*Proceedings of the Madras Government, Judicial Department,
8th October 1867.*

No. 48. From R. S. ELLIS, Esq., c. B., Sanitary Commissioner, on special duty at Kurnool, to the Chief Secretary to Government, Fort Saint George; dated Kurnool, 20th November 1866, No. 288.

ORDER THEREON, 8th October 1867, No. 1596.

1 to 32 Ventilating openings each 8 inches square: the wall is three feet thick.

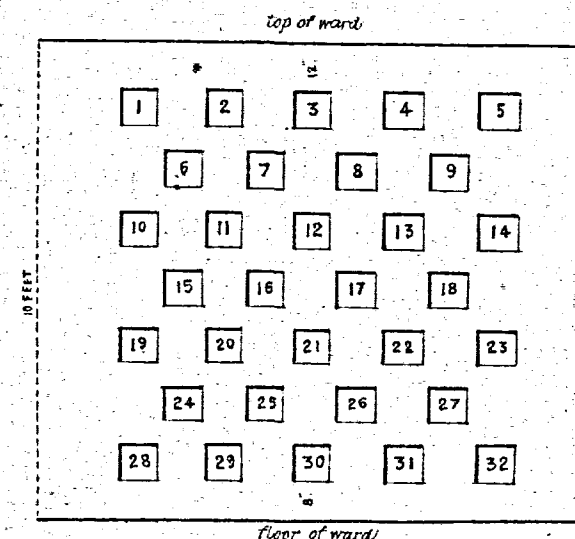
The Jail was throughout very much overcrowded, but, owing to the new wards having their front and end walls perforated by honeycomb openings (as shown in the margin), and in consequence of the substitution of a stout wooden railing in lieu of the front wall of the old wards, they were all found singularly free from the sickening smell experienced in crowded buildings which have been occupied during the night time.

The honeycomb openings commence within 8 inches of the floor on which the prisoners sleep, and extend to within 12 inches of the roof. Seven tubu-

lar roof-ventilators are also introduced, and carry away vitiated or heated air, and a constant supply of fresh air reaches the ward through the honeycomb openings, of which there are seven sets in each ward.

13. As regards the construction of the new wards, I think the honeycomb openings in the walls of the four wards, which I have described above, should be imitated. The ventilation in these wards is remarkably good, when their small size and crowded condition are considered, and this method of ventilation is probably the most economical in districts where the use of wood and iron is very expensive and entails much delay.

But more care must be taken in any new wards that are built than was given to the four wards described above. They have not been built much more than one year, and their walls are cracking in a manner to make these wards very unsafe.
